**RE: Response to Comments**

**The Aurora Highlands Lennar Phase 1 – Site Plan – First Review**

**Application Number: DA-2062-61**

**Case Numbers: 2024-4018-00, 2024-3038-00**

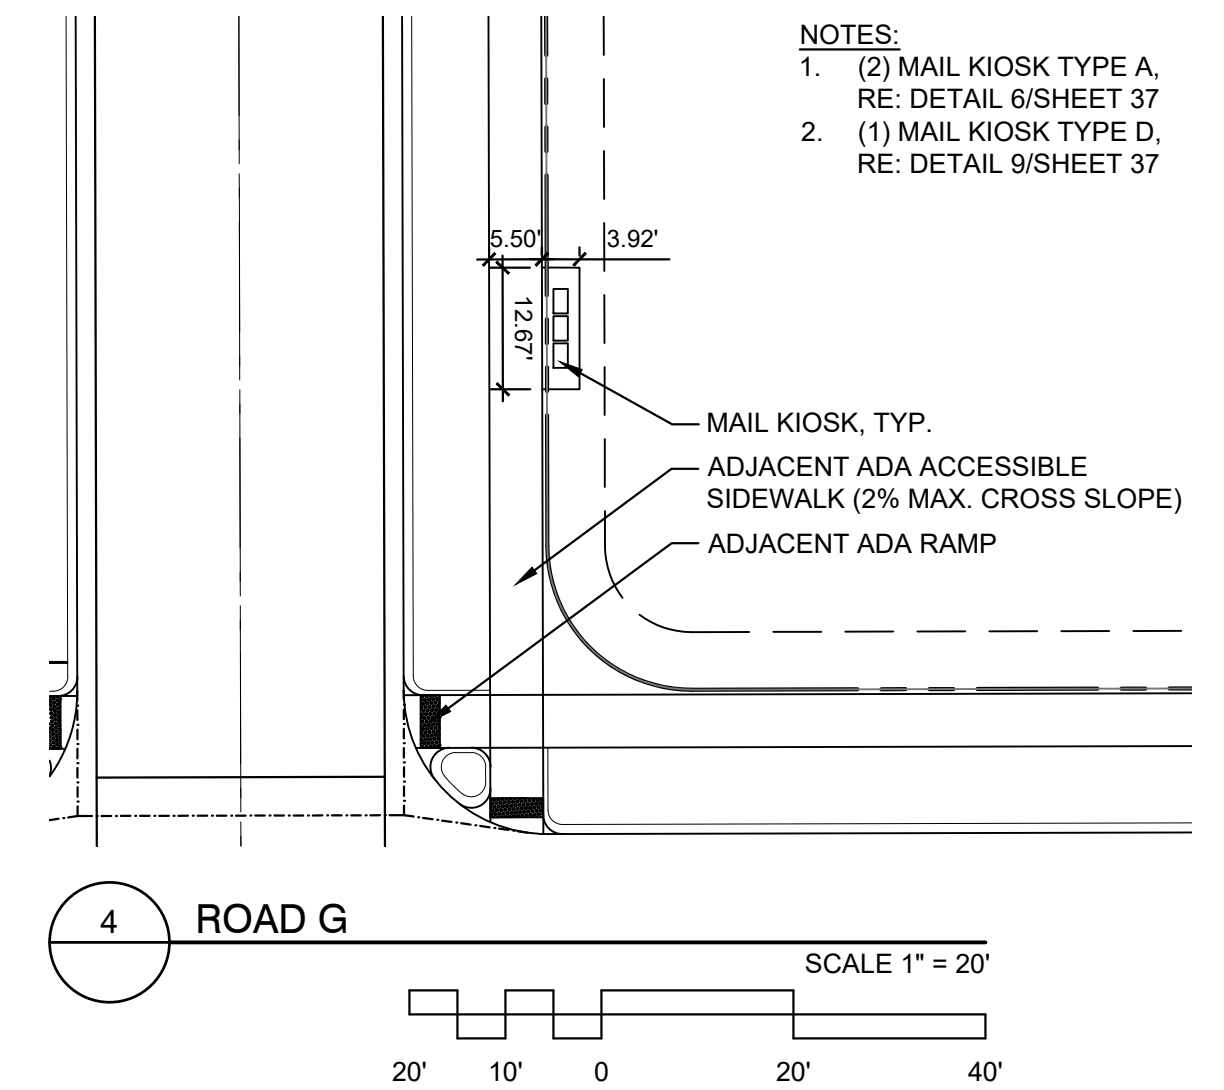
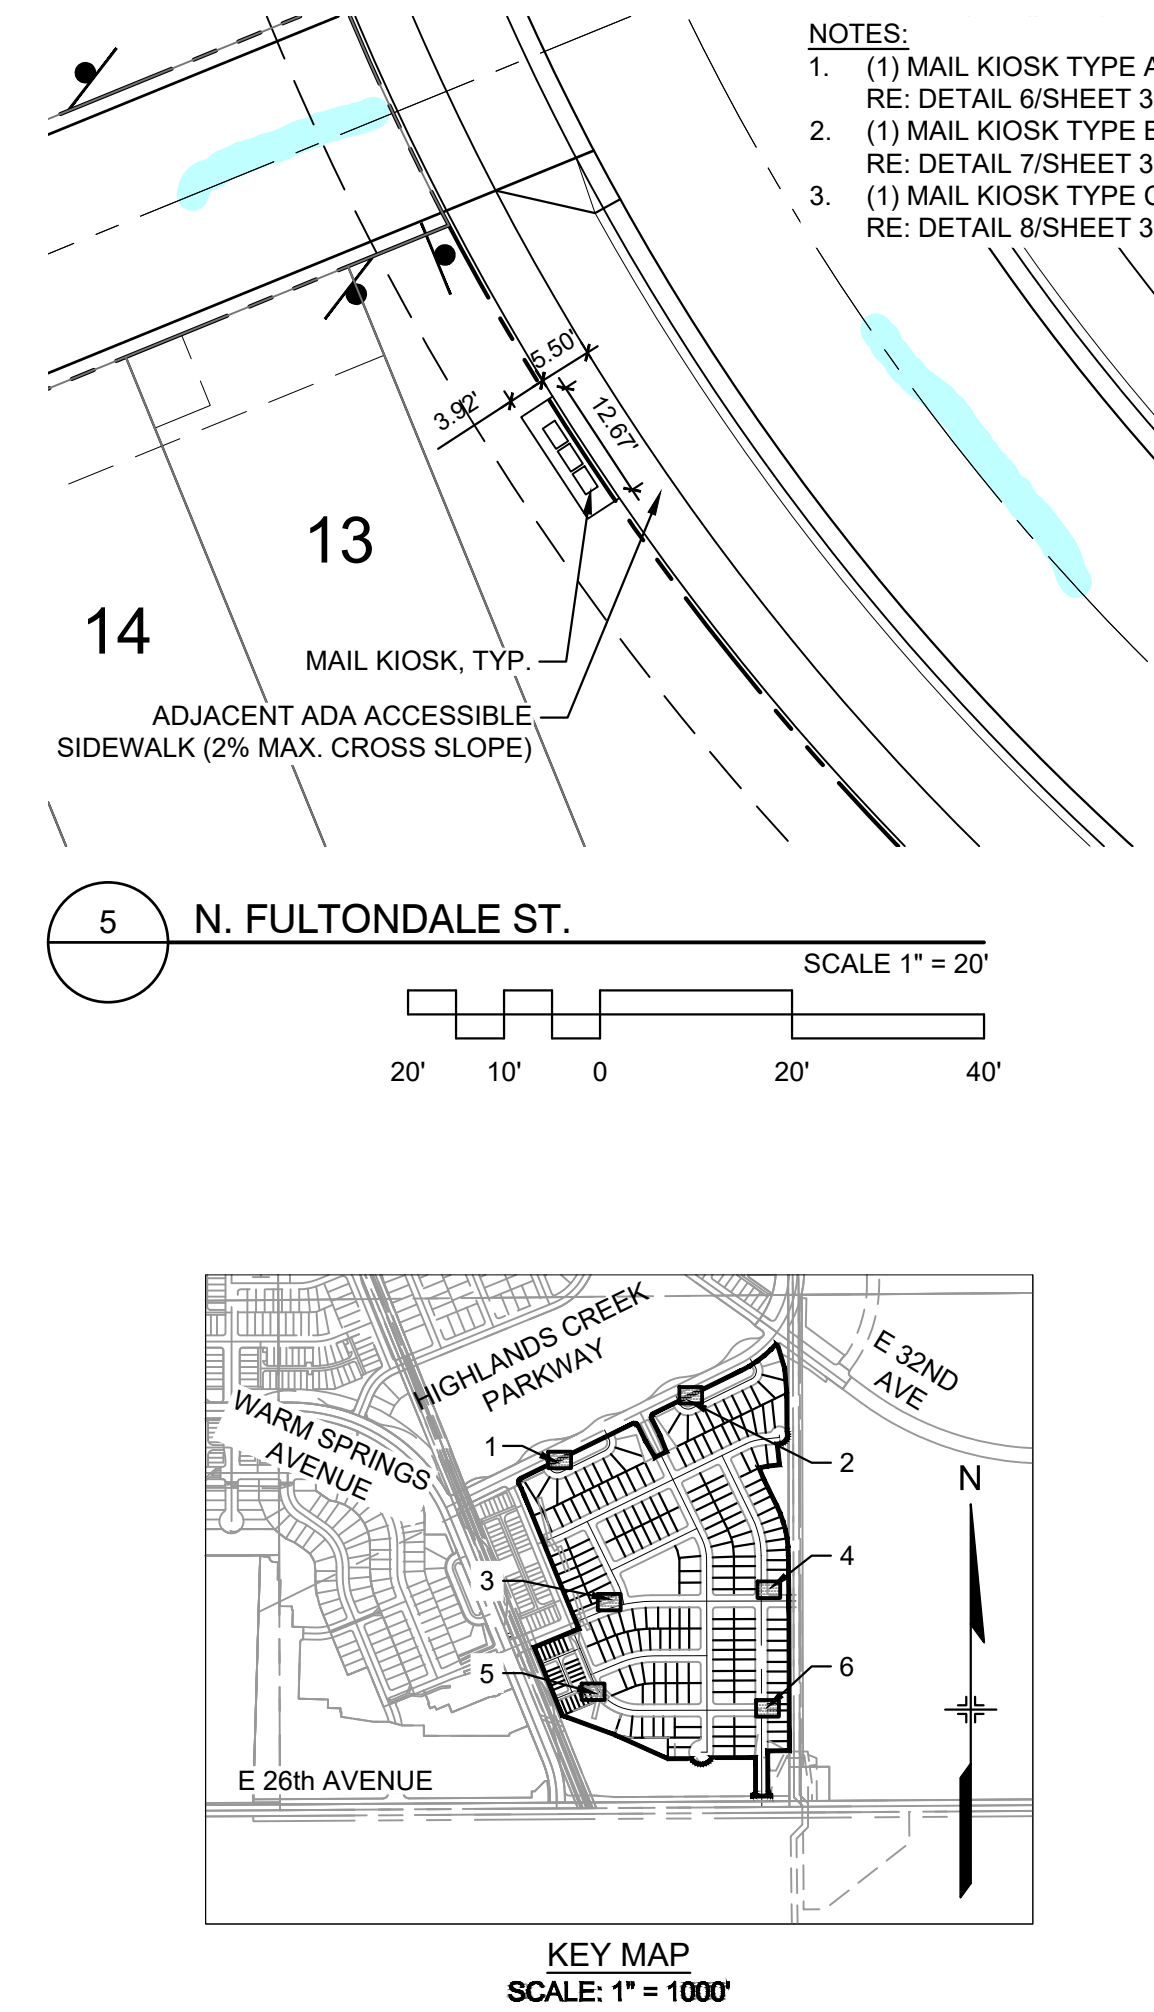
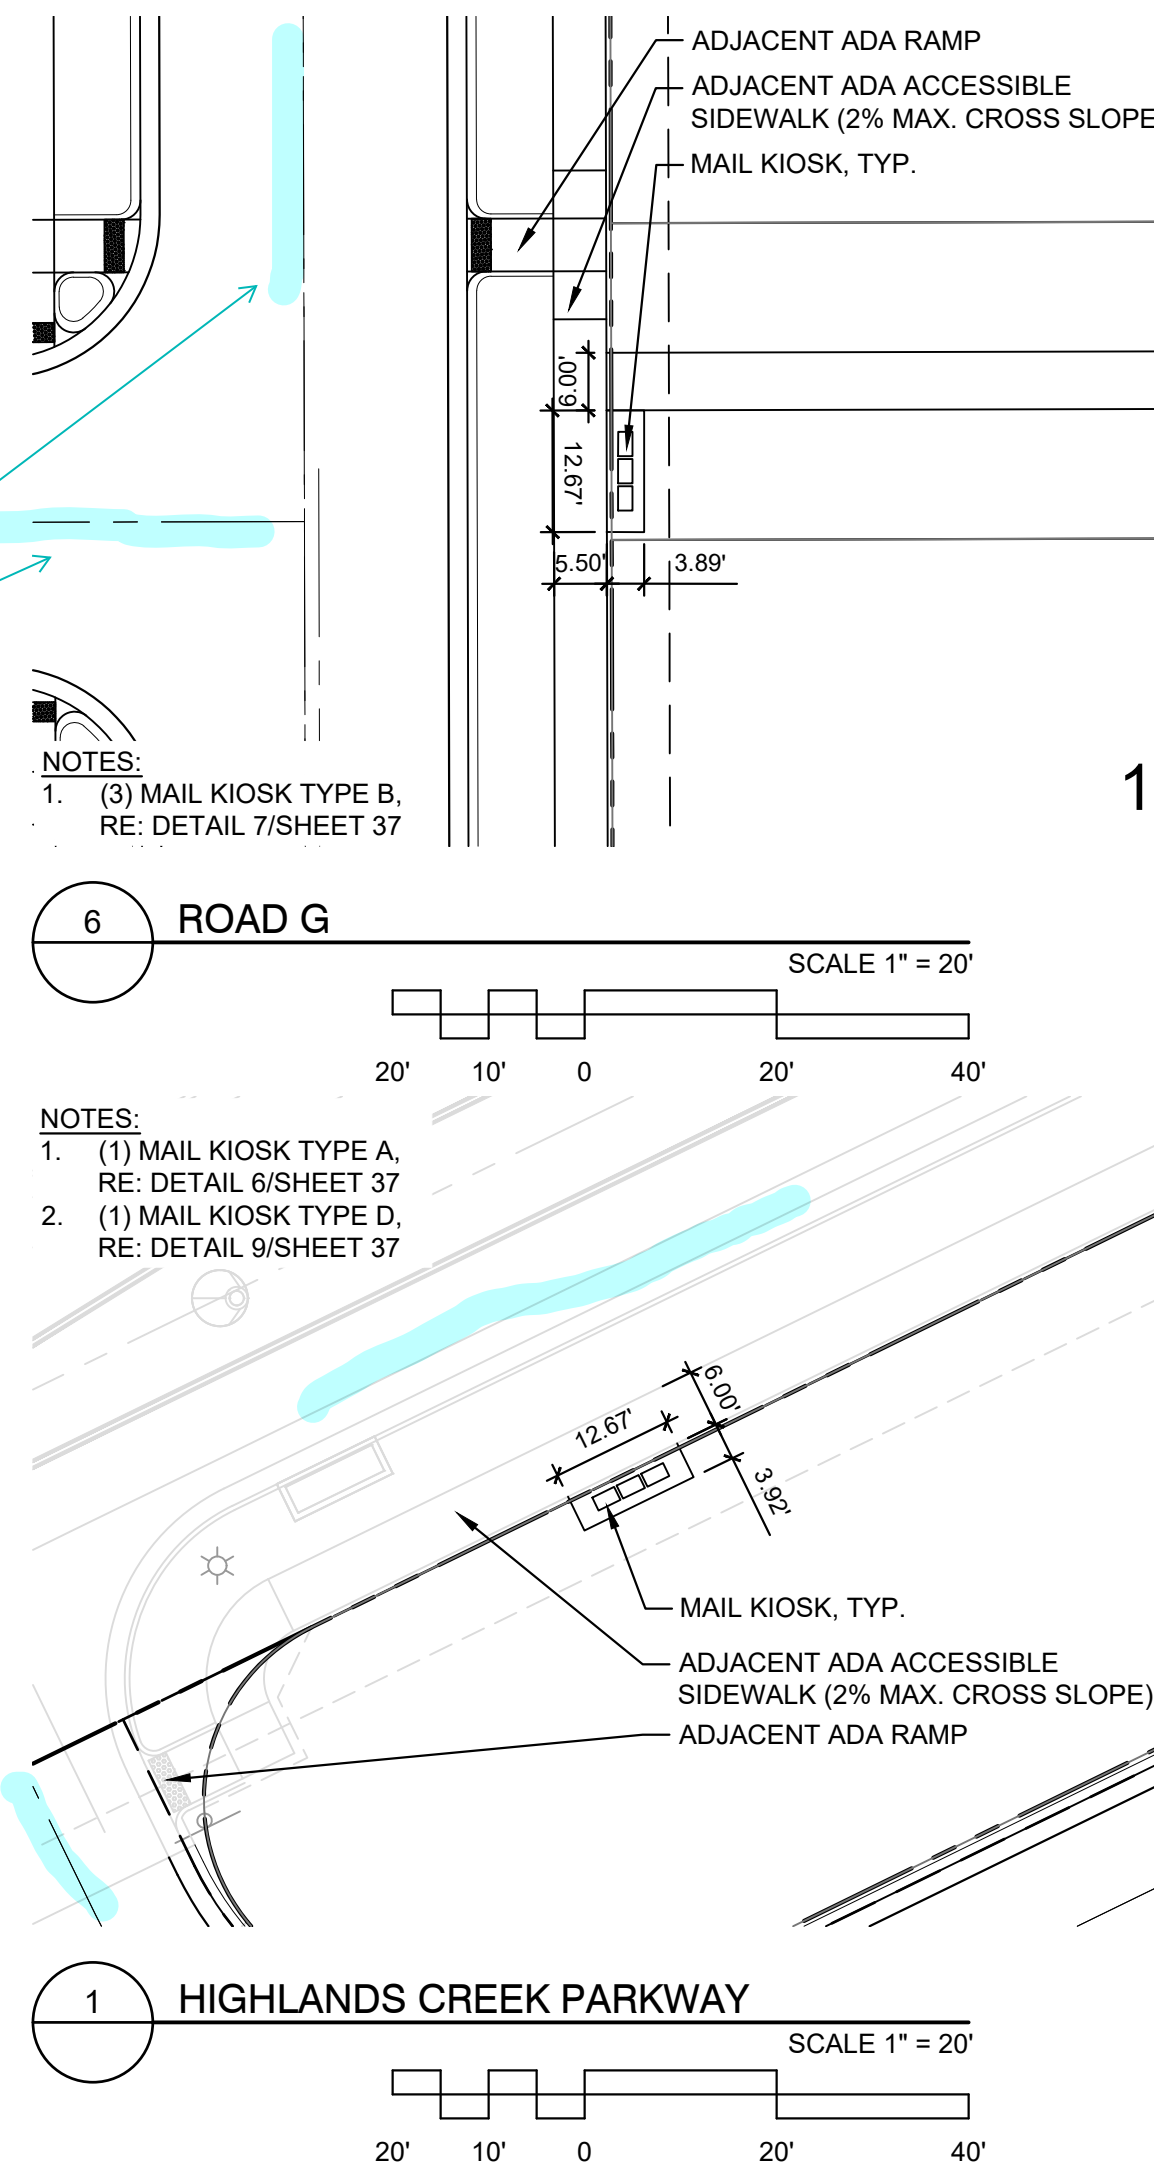
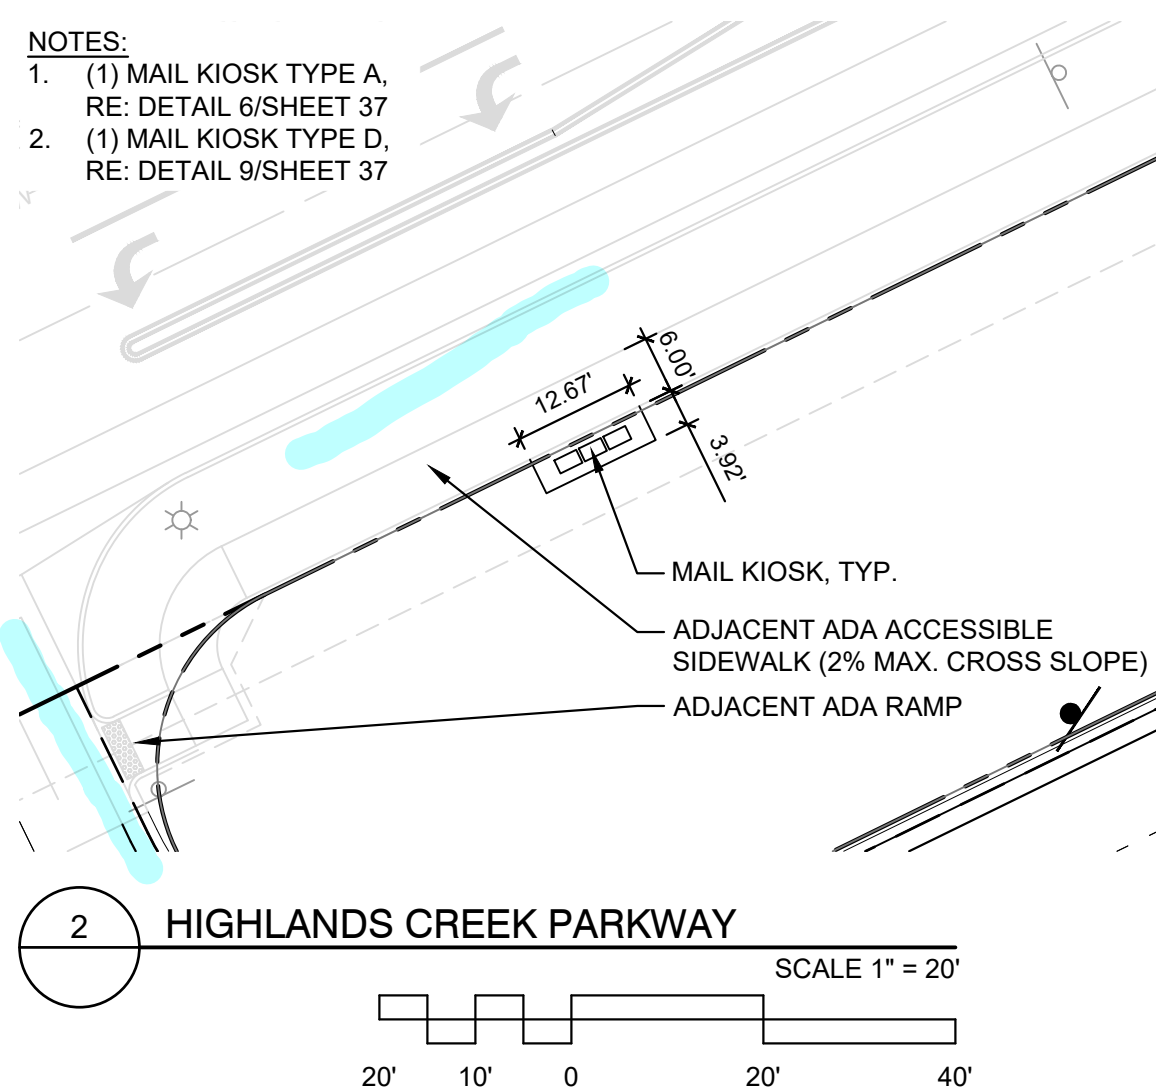
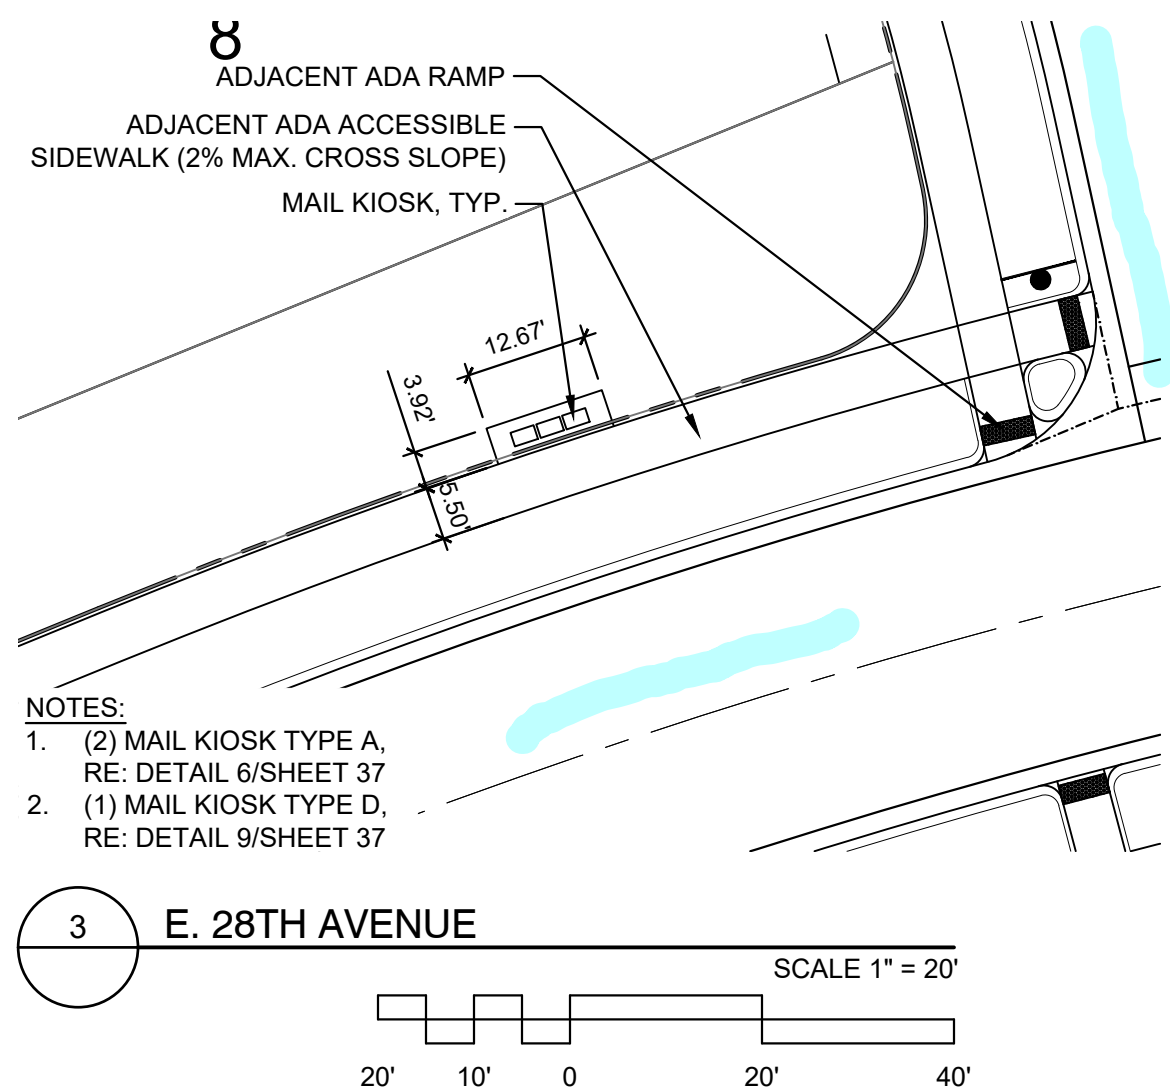
label all street segments and  
intervening streets  
TYP

***Response: All streets and classification are now labeled on all landscape sheets.***

2 TYPE 'SL1' LED POST TOP LIGHT

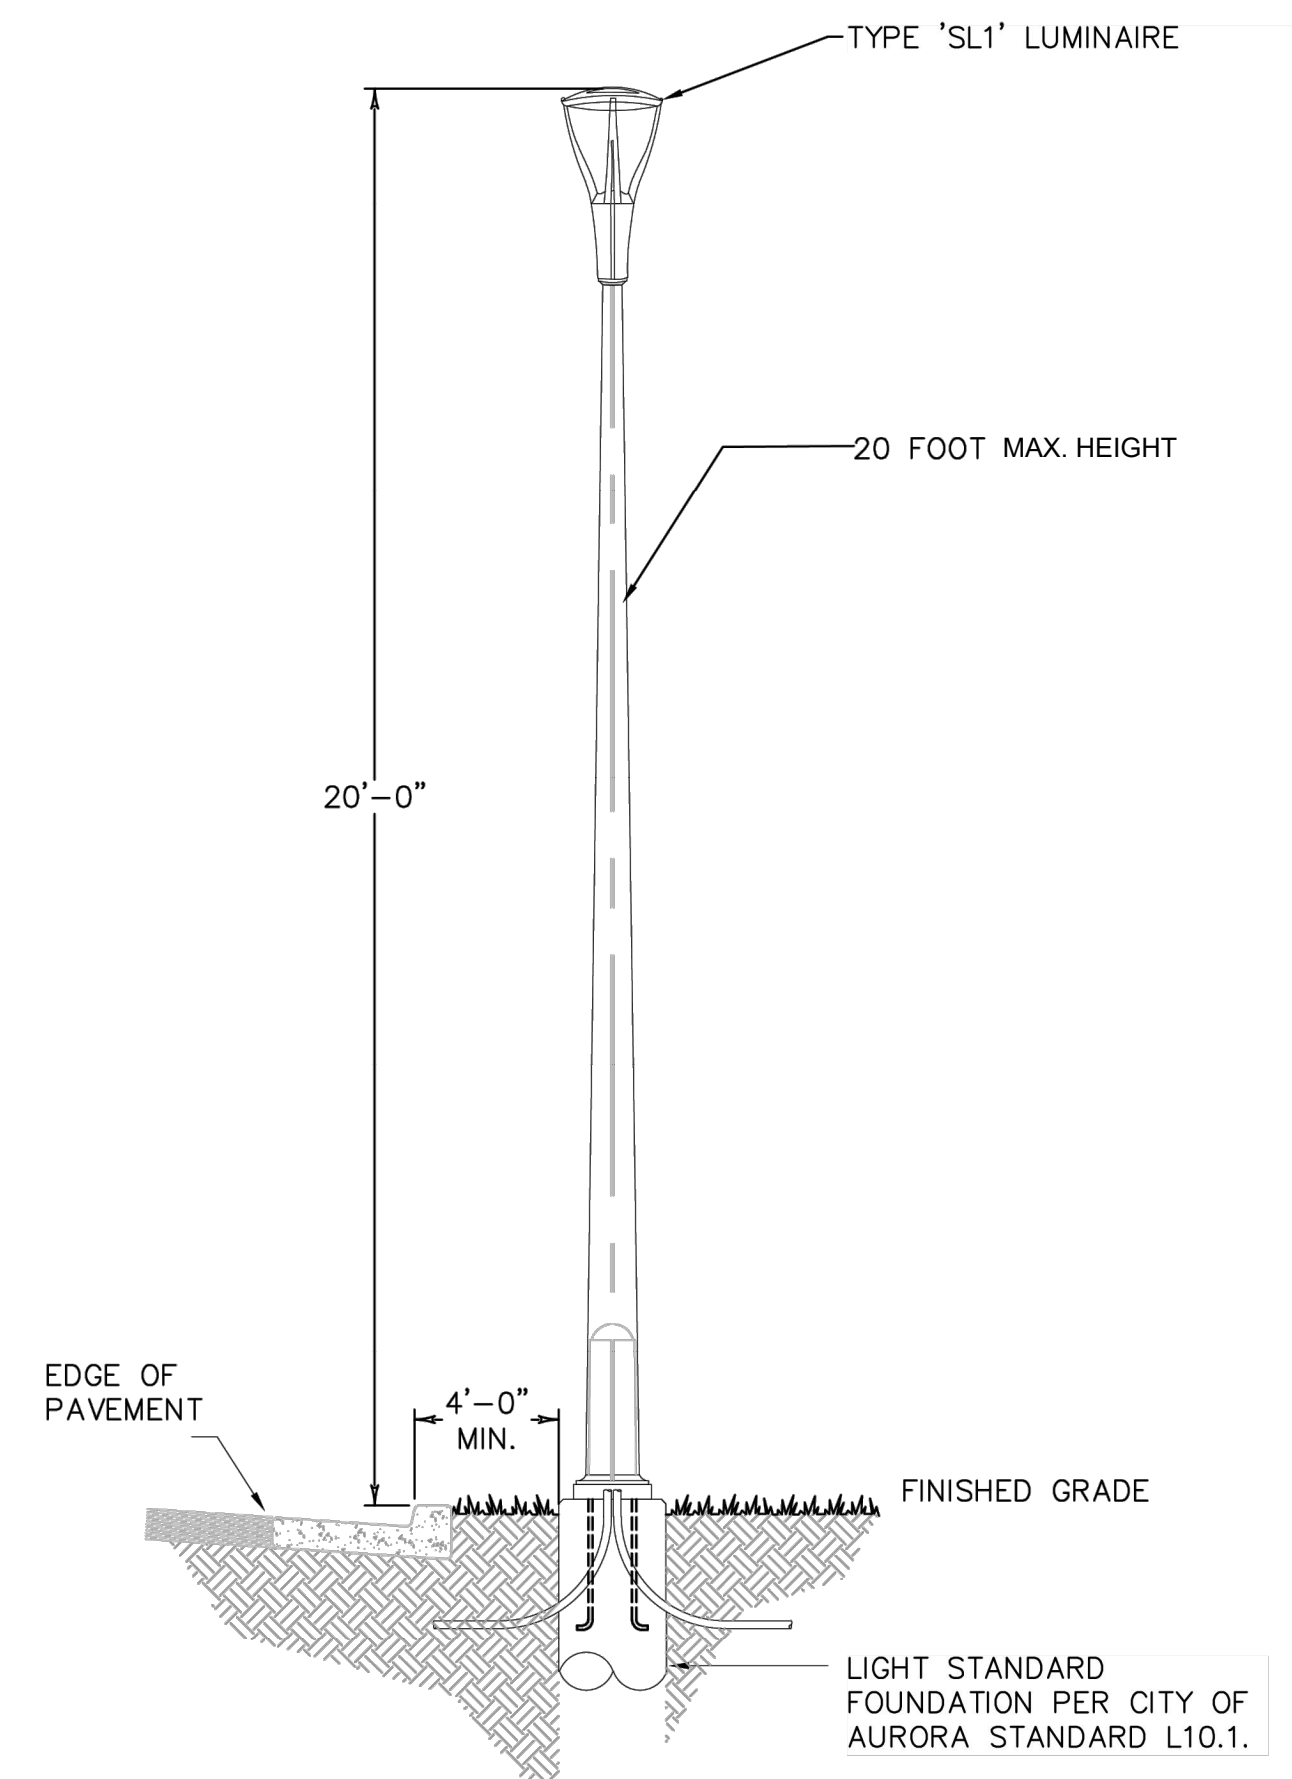
Refer to the roadway manual fixture type.  
Use details to specify height.

***Response: Roadway manual fixture types for streetlights have been specified. Only one street light type is shown in the details.***
